ANALYSIS

**EXHIBIT A
DEPARTMENT REVIEWS**

General RV Site Plan Amendment

14295 S. Minuteman Drive

EXHIBIT H
ELEVATIONS

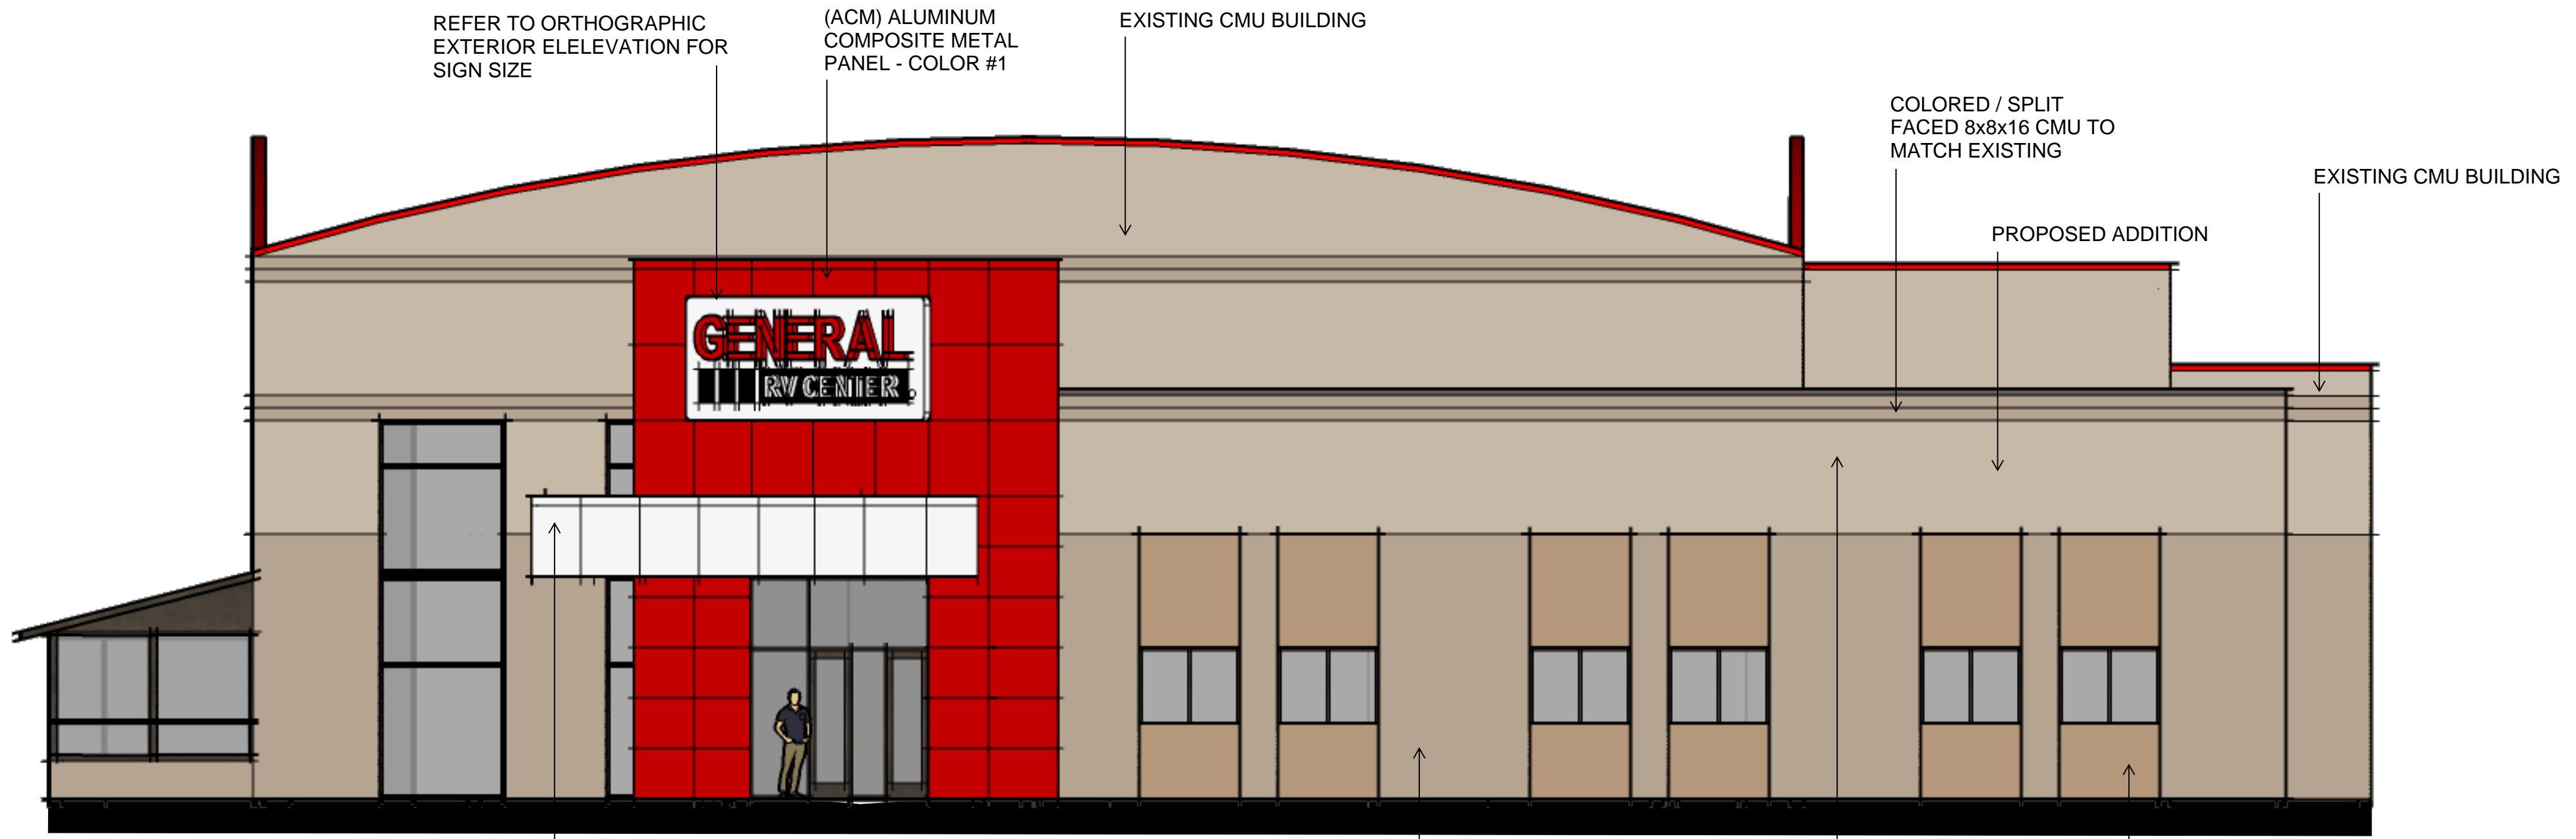
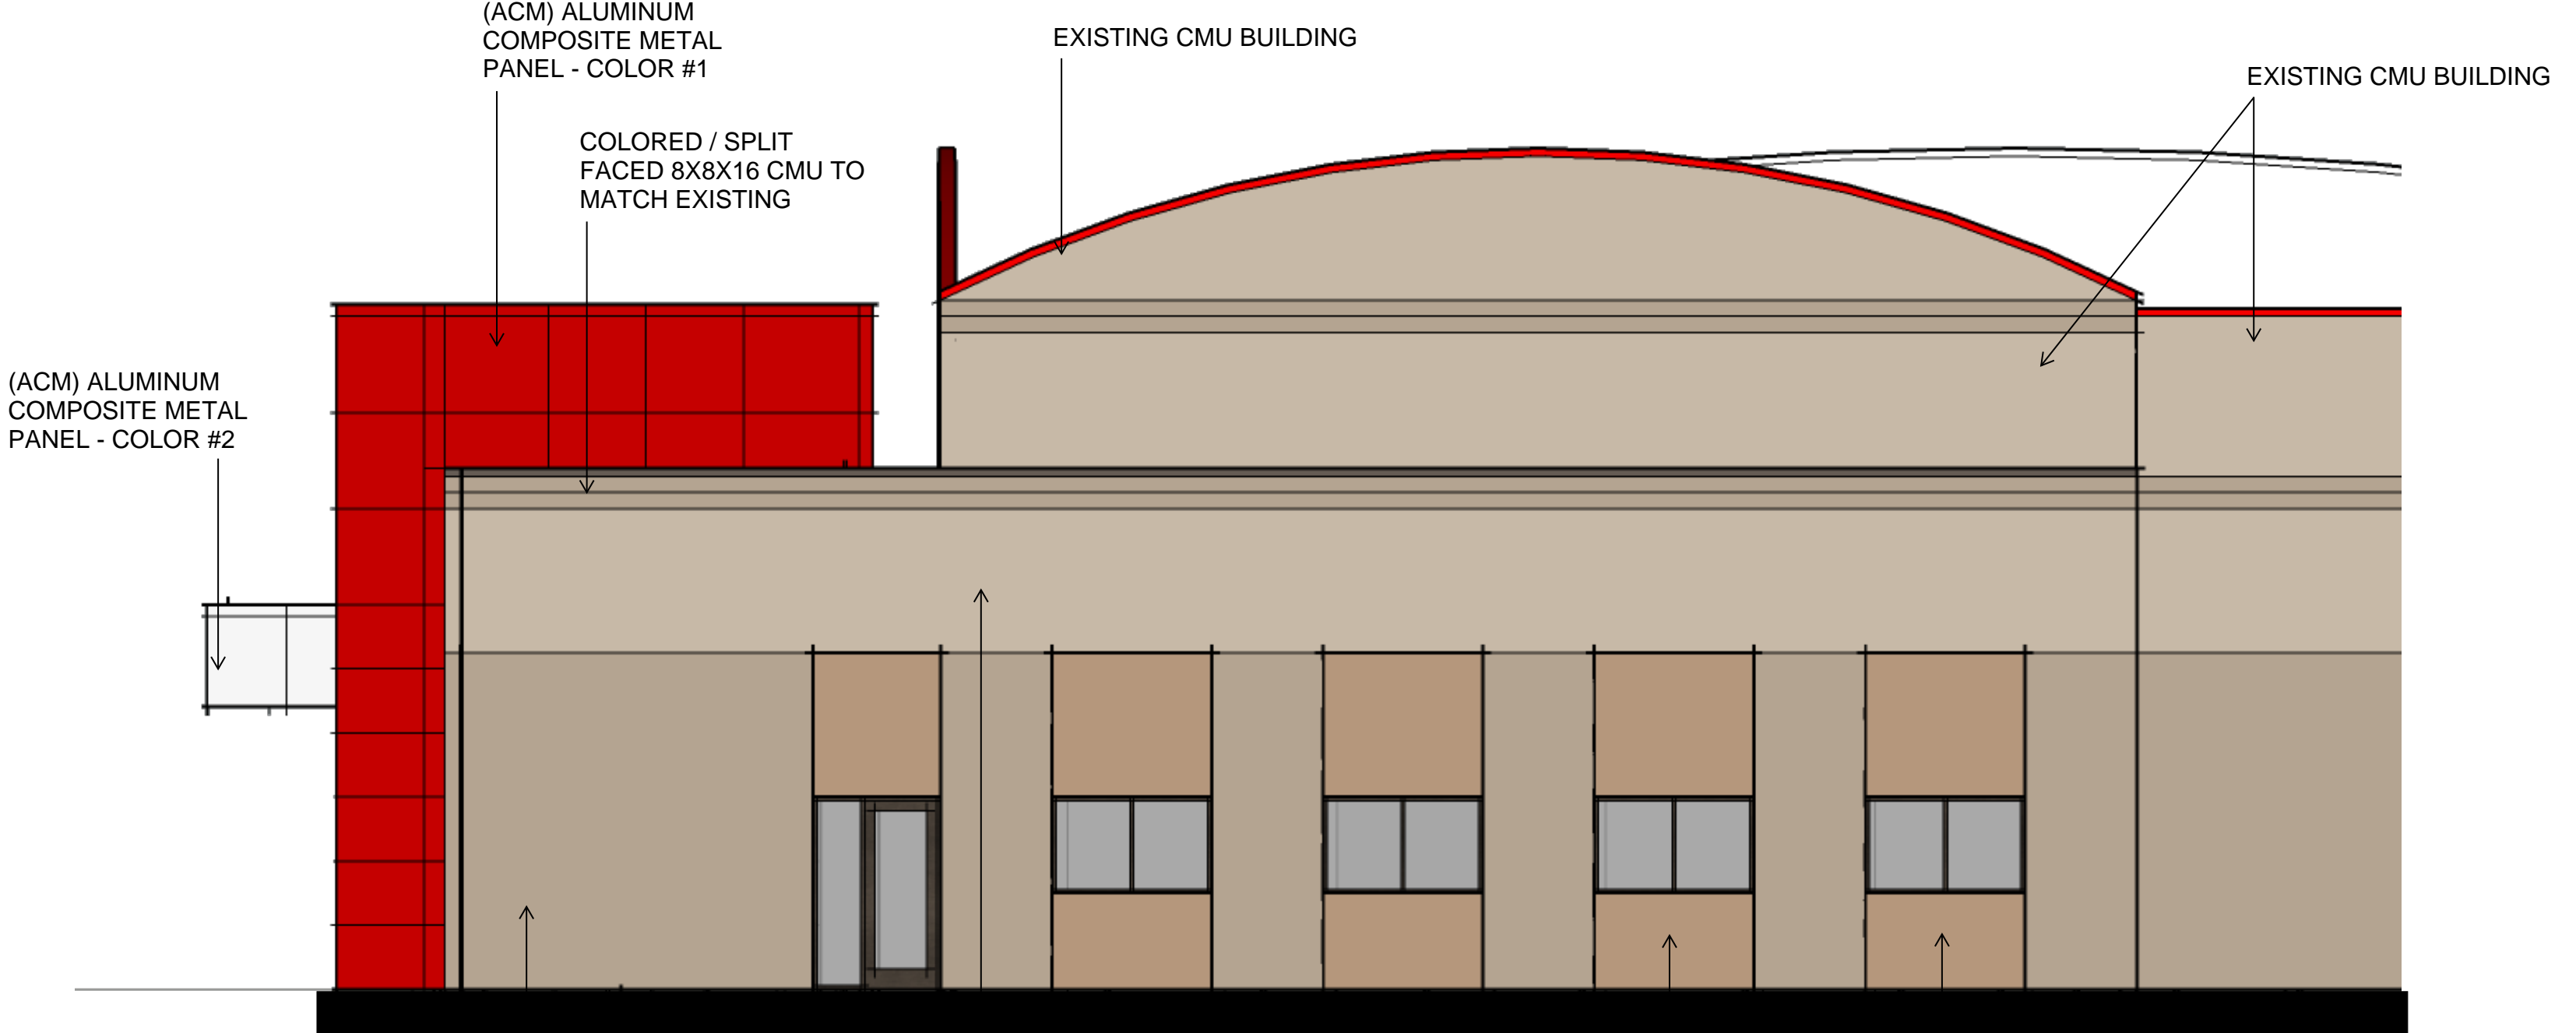
Architecture. The Elevations (Exhibit H) show the proposed design of the approximately twenty-nine foot (29') tall addition. The primary materials are split faced concrete masonry unit (CMU), aluminum composite metal panels, and brick. Smooth faced CMU will also be incorporated into the facade. The CMU and the brick will be color matched to the existing materials, and the aluminum composite metal panels will be provided in two (2) colors.
